Crud-Related  
and  
Breakaway Oxidation Presentation

Mr. Mark Leyse

June 24, 2014

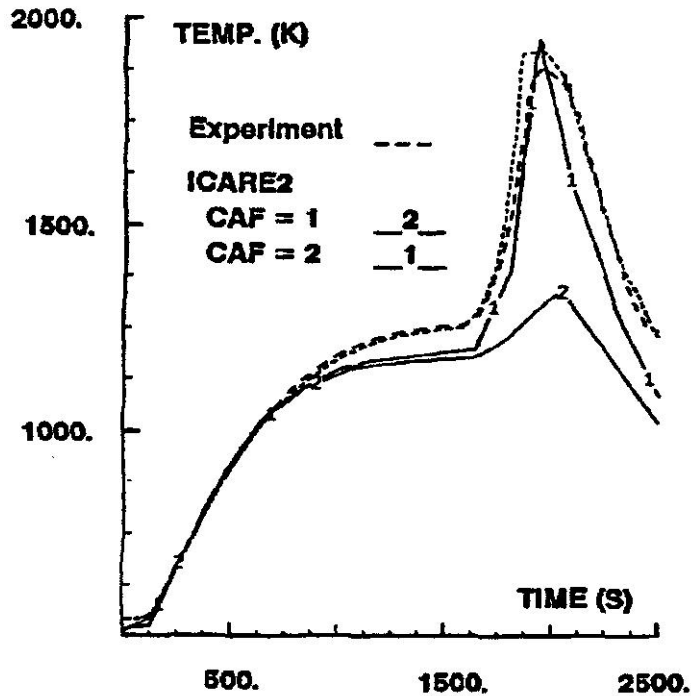
A RELAP5-3D model of a reference Westinghouse four-loop PWR plant that MIT developed for a previous study was used. RELAP5-3D simulated a LB LOCA—a double-ended guillotine break—at the modeled plant: surface temperatures of clean fuel cladding were compared to those of fuel cladding with a 100  $\mu\text{m}$  thick crud layer. For both cases, surface temperatures of the hottest fuel rod of the hottest assembly were examined.

The RELAP5-3D analysis demonstrated that the peak cladding temperature (PCT) of the crud case was 77 Kelvin (139 Fahrenheit) higher than that of the clean-cladding case, for the postulated LBLOCA. Hence, the thermal resistance of crud deposits on fuel cladding needs to be considered in LOCA analysis for licensing and other related activities.
